United States Golf Association

Notice To Manufacturers

Head Size and Club Length Limits

Clubhead Dimensional Measurements

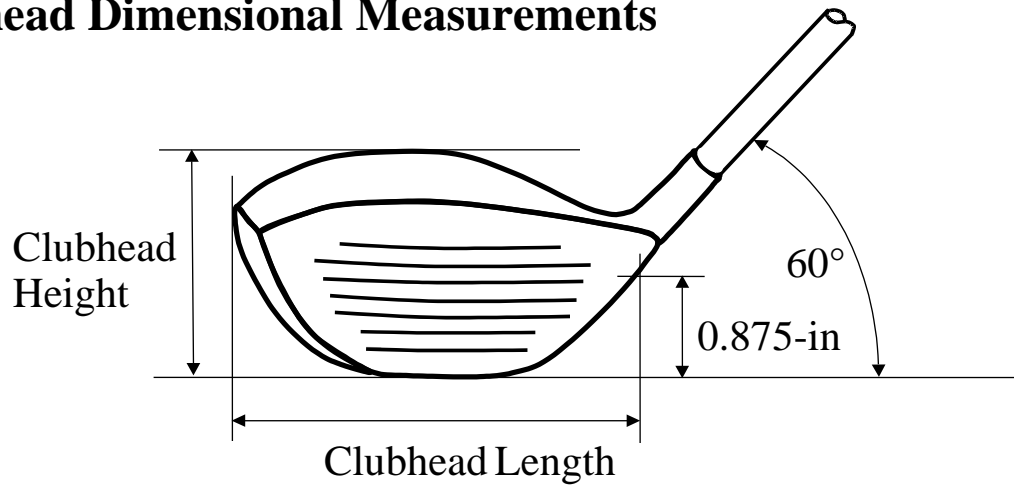
The USGA has previously proposed a clubhead volume limit of 460 cc plus 10 cc for measurement tolerance. We have received many comments regarding that proposal. In addition to the previously made volume proposal, the USGA is now proposing that clubhead heel to toe length and clubhead sole to crown height will also be limited. The USGA believes that the use of both volume and dimensional controls will define the size limitations more effectively than either volume or dimensions alone. Clubs will be required to conform to both volume and dimensional limits to be considered conforming.

Clubhead dimensions will be measured with the head positioned at a 60 degree lie angle. If the outermost point of the heel is not clearly defined, it will be deemed to be 0.875 inches above the horizontal plane on which the club is lying. The proposed limit for clubhead heel to toe length is 5.0 inches. The proposed limit for sole to crown clubhead height is 2.8 inches. Both dimensional limits include an allowance for measurement tolerance. The method used to measure clubhead length and height is illustrated in the attached drawing.

The USGA has previously proposed a club length limit of 47 inches for clubs other than putters. We have received many comments regarding that proposal. The USGA is now proposing to increase the club length limit for clubs other than putters to 48 inches. The measurement method is to be made with the club in a 60-degree lie angle position from the ground plane to the end of the grip. This measurement method is illustrated in the attached drawing.
